RECOMMENDED SERVICE BULLETIN

NO. RSB 40-045

NO. RSB D4-033

The installation of a EMI-Filter on the ELT Remote Control Cable.

Drawing No. DA4-2560-00-00-SB

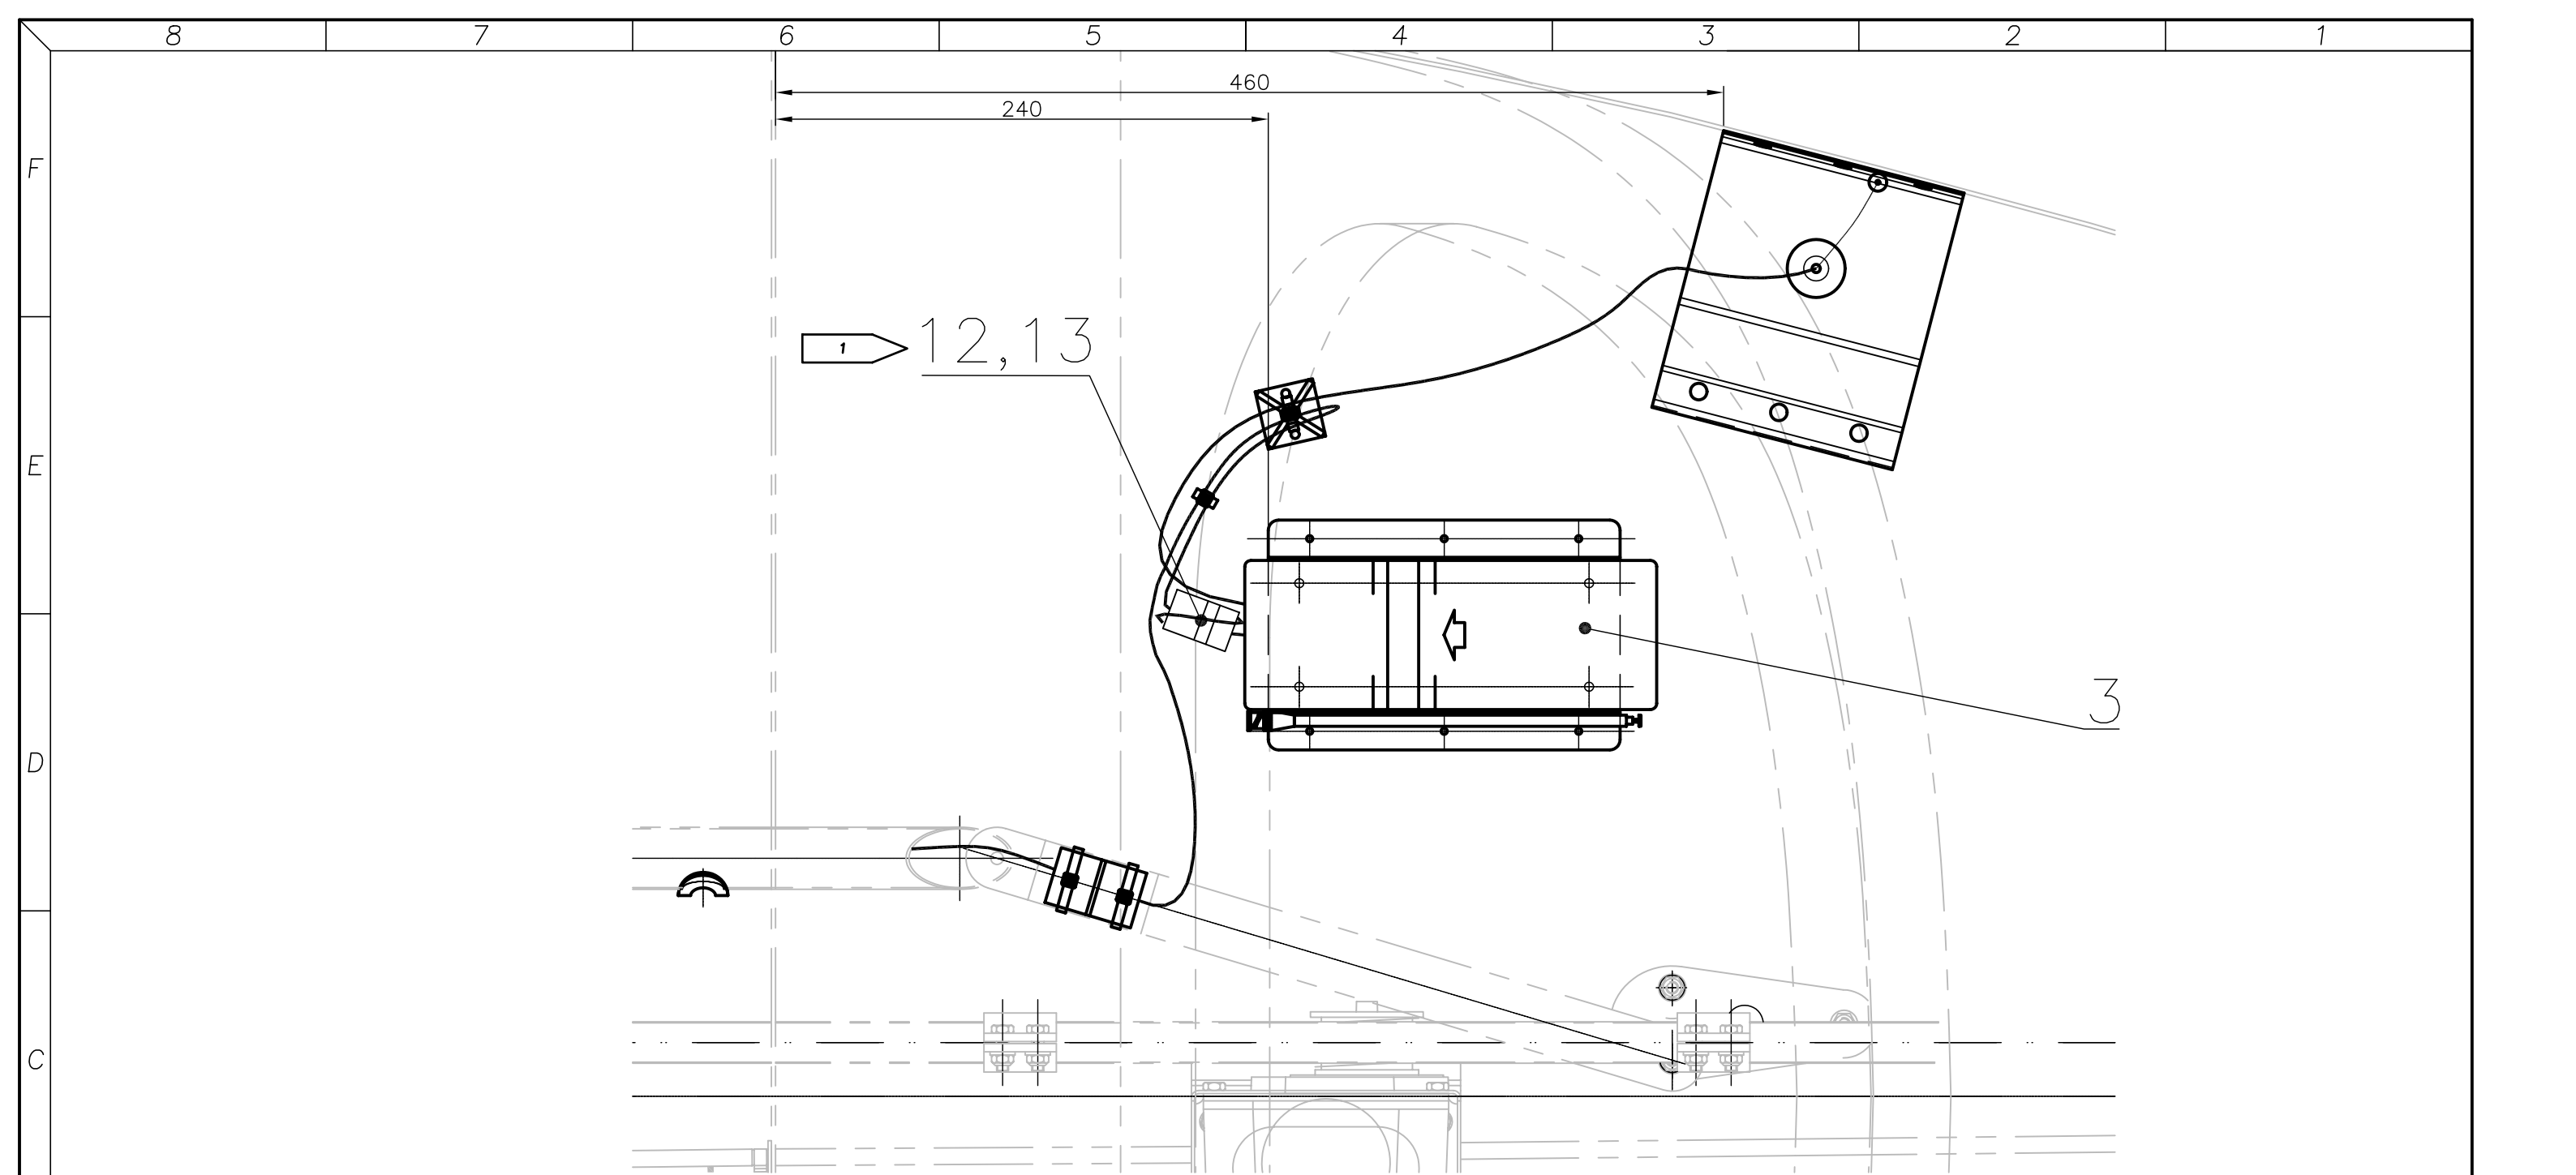
- Install EMI-Filter on ELT Remote Control Cable in accordance to drawing no. DA4-2560-00-00-SB

1 INSTALL FILTER AS CLOSE TO ELT UNIT AS POSSIBLE AND SECURE WITH TYRAP.
